**CONTRACT ADDENDUM #**

**date:** 5.10.24  
**project:** Hyde Park Middle School  
**by:** Michael Rigby  
**subject:** Addendum 02

**HPMS ADDENDUM #2**

**SUBJECT:** **Addendum #2 – Changes to Bid Package #1**

**CIVIL - ROADWAY PLAN & PROFILE**  
 200 SOUTH

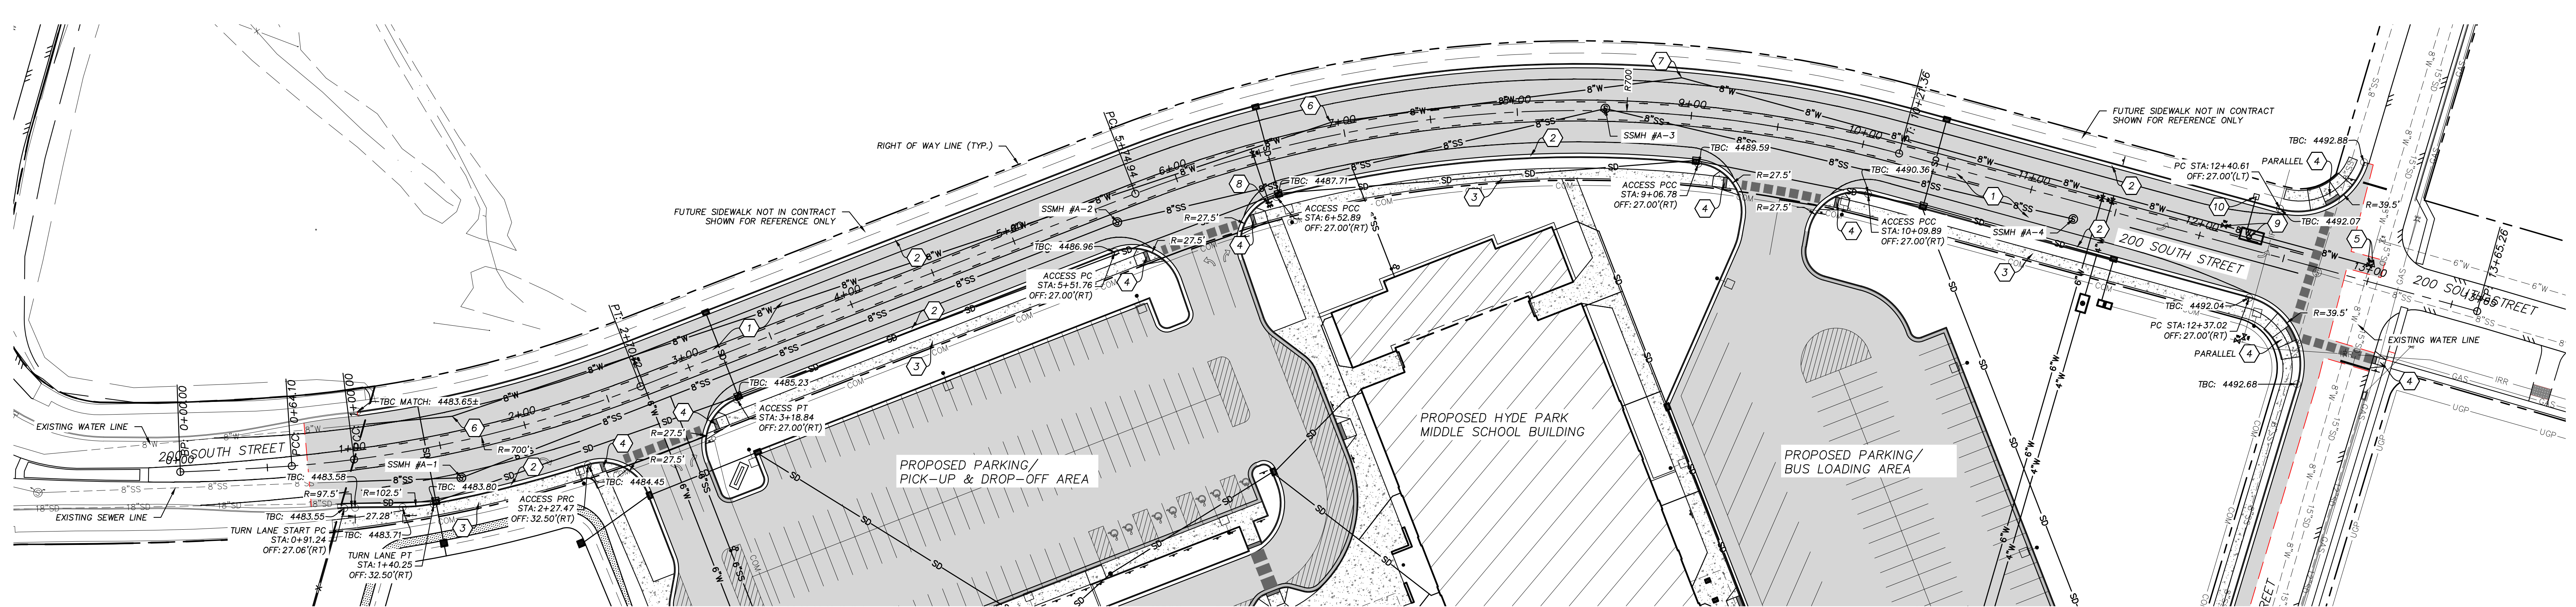
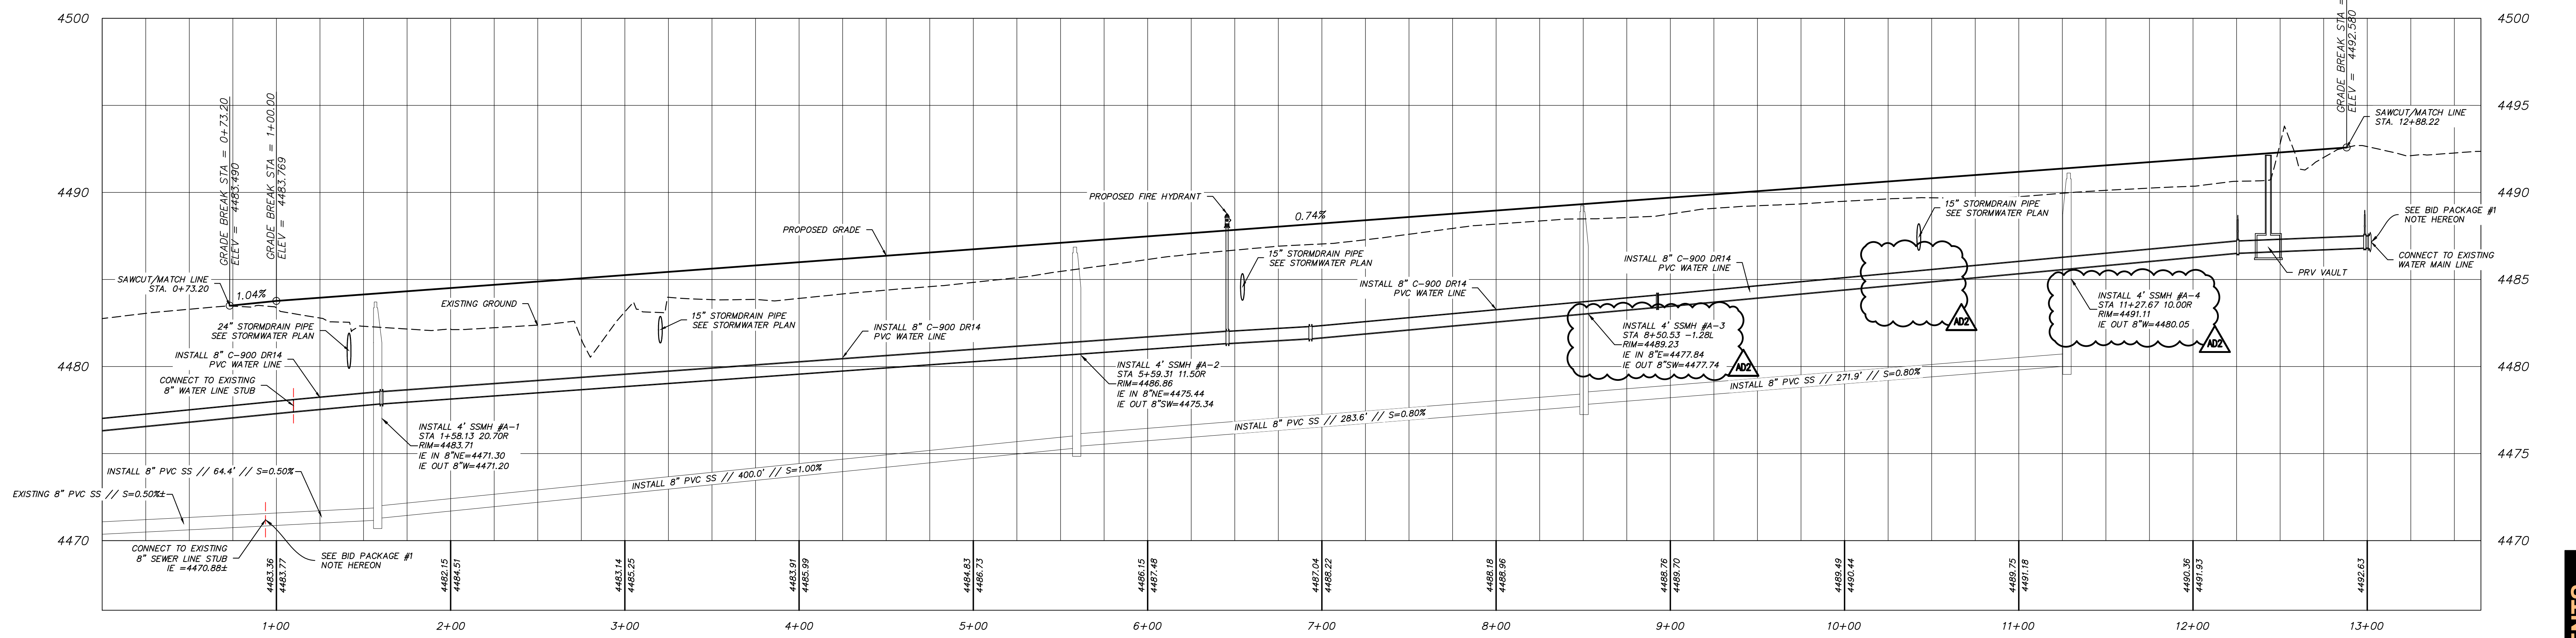
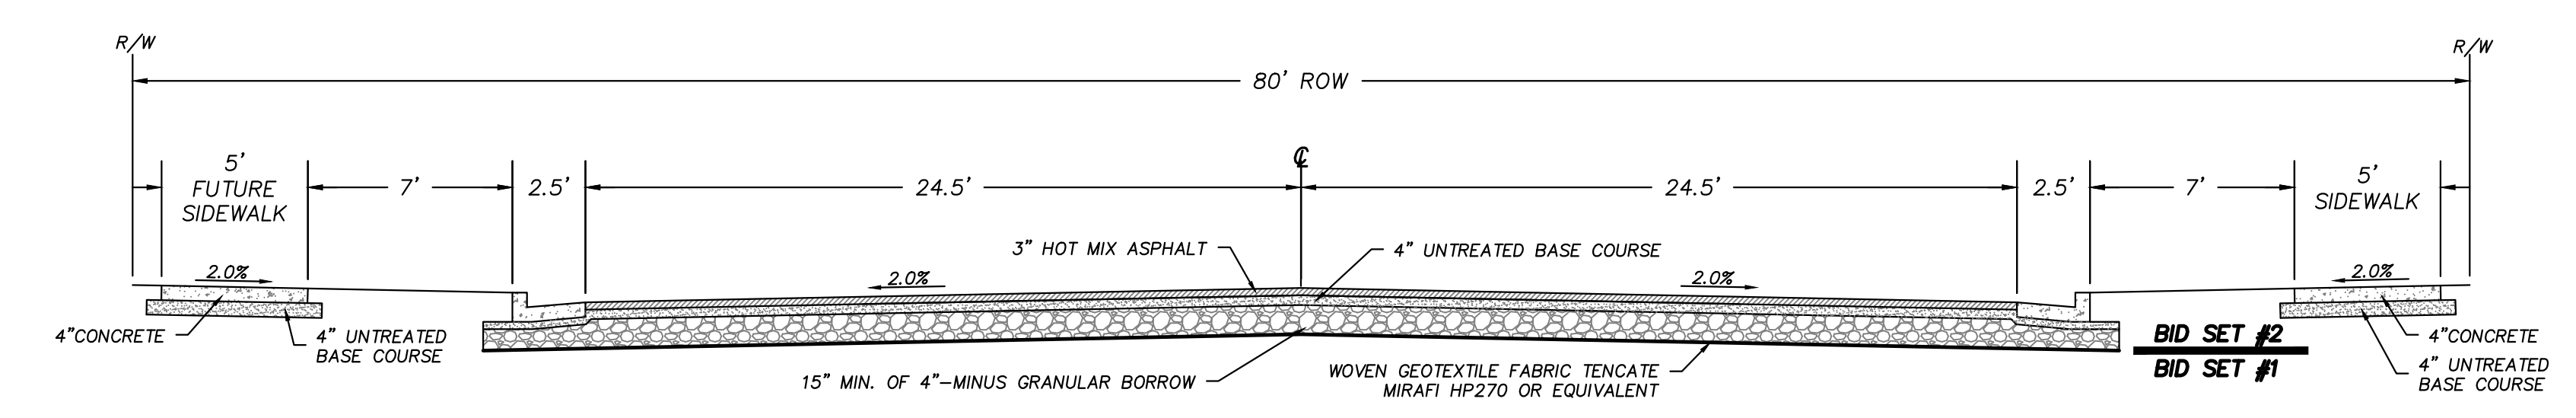
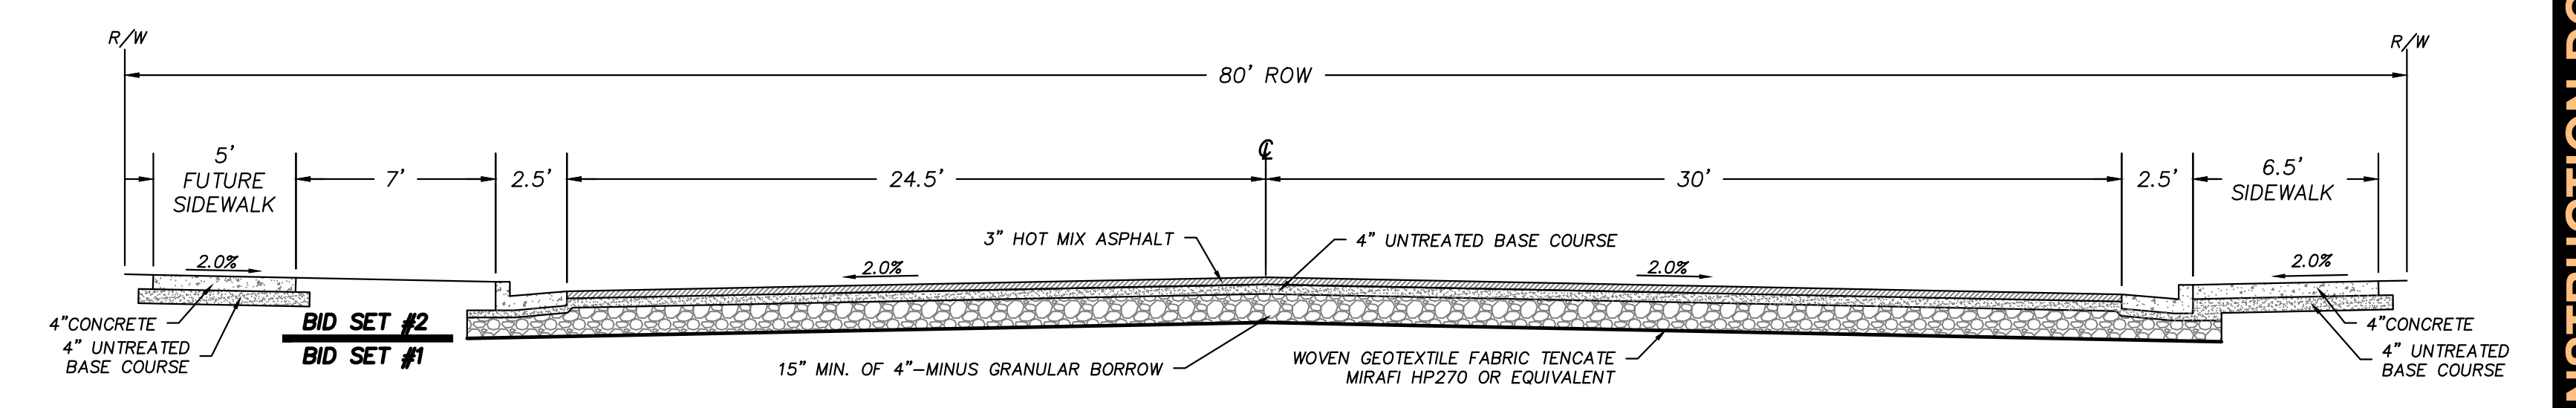
- a. **ADDED** – Mirafi HP270 or equivalent geotextile fabric under 12” Granular Borrow in School Bus parking areas. See Detail #1.
5. **Civil – Roadway Plan & Profile – 200 South, Sheet C-601.**

- a. **REMOVED** – Water line loop for storm drain line crossing at sta. 10+42.63.
  - b. **CHANGED** – SSMH #3 location and elevation adjusted to accommodate storm drain design.

- c. **CHANGED** – SSMH #4 location and elevation adjusted to accommodate storm drain design.
